**FIRST AMENDMENT  
TO  
COST REIMBURSEMENT AGREEMENT**

Reference is made to that certain Cost Reimbursement Agreement entered into as of March 31, 2014 between **NIAGARA MOHAWK POWER CORPORATION** and **ROCHESTER GAS AND ELECTRIC CORPORATION** (the “Agreement”). Unless otherwise defined herein, all capitalized terms in this First Amendment to Cost Reimbursement Agreement (“First Amendment”) shall have the meanings set forth in the Agreement.

**Technical Scope Document for Substations  
(Mortimer – Protection and Station upgrades for  
line 901 re-conductoring)**

### Mortimer – Protection and Station upgrades for line 901 re-conductoring

# 16.2 Attachment #2: Proposed One Line / Operating Diagram

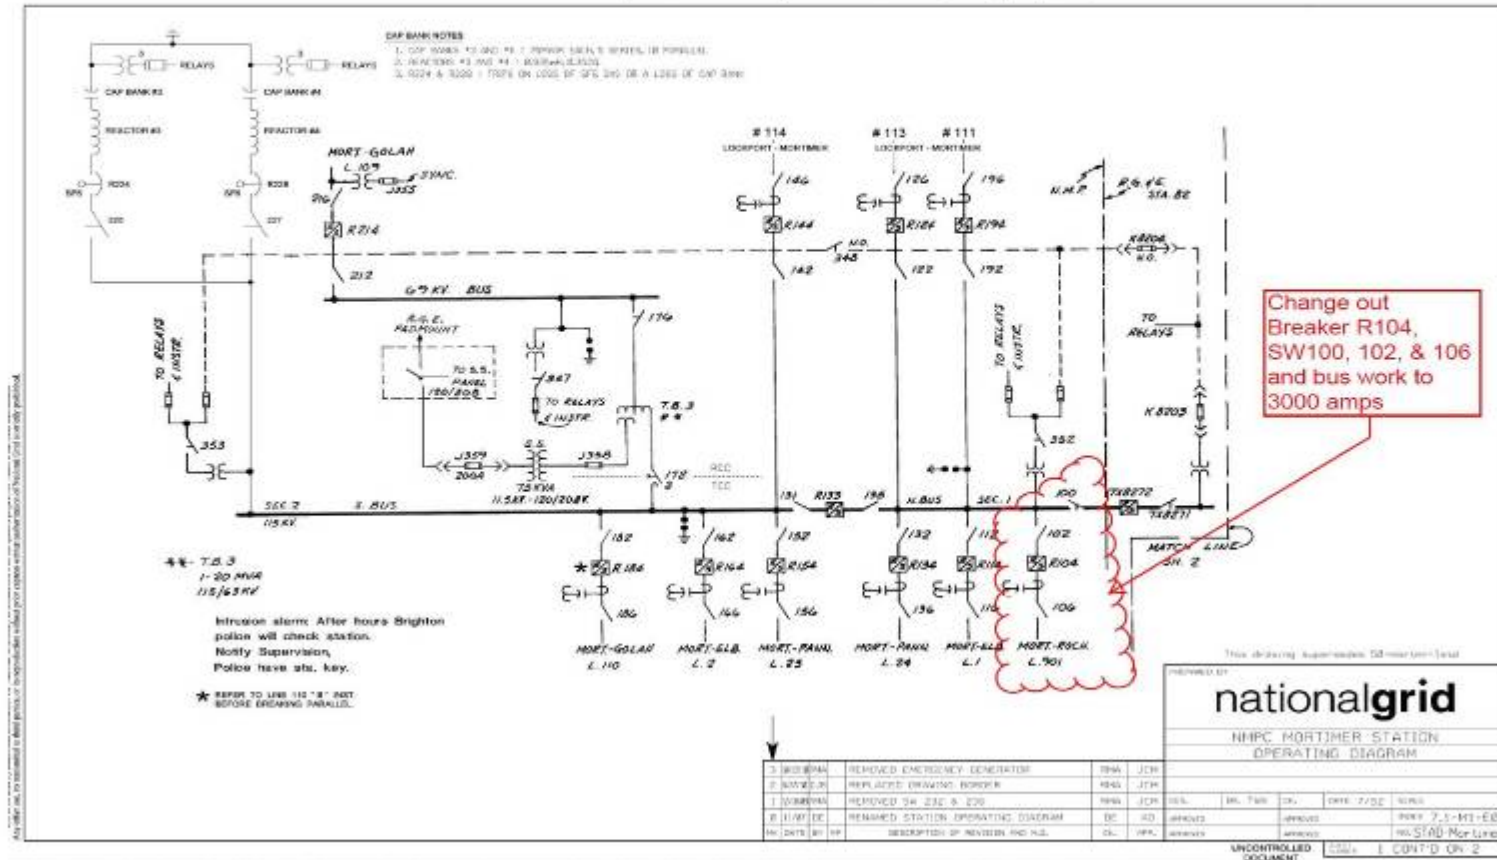
Phase 2 of the project is to upgrade the Mortimer Substation to be able to handle 400 MVA summer normal and 640 MVA long time emergency (LTE) due to the re-conductoring of line 901. Line 901 is being upgraded by RG&E to 2-1192.5MCM ACSR Bunting conductor. The scope at Mortimer Substation for phase 2 includes replacing Circuit Breaker R104, disconnect switches SW102 and 106, and bus work to a 3000 amp rating. Also the 115kV take off structure will be modified to handle the new 2-1192.5 conductor on line 901. In addition the bushing potential device will be replaced with a CVT.

4.3.1 Replace GE type "FK" Oil Circuit Breaker R104 with a 115kV 3000A 63kA SF6 Breaker per specification SP.04.01.002 46kV-345kV Power Circuit Breakers (SF6). The circuit breaker will have dual trip coils in order to comply with NPCC bulk power directory 4 requirements. However Mortimer does not have two battery sources and we will not meet all the bulk power requirements. The station was not designed to meet bulk power requirements.

4.4.1 Replace disconnect switches SW102 and 106 with 123kV 3000 amp group operated air break, vertical break switch per specification SP.04.09.001 Group operated outdoor air break disconnect switch.

4.4.2 Replace gang disconnect switch SW100 with a 123kV 2000 amp group operated air break, vertical break switch per specification SP.04.09.001 Group operated outdoor air break disconnect switch.
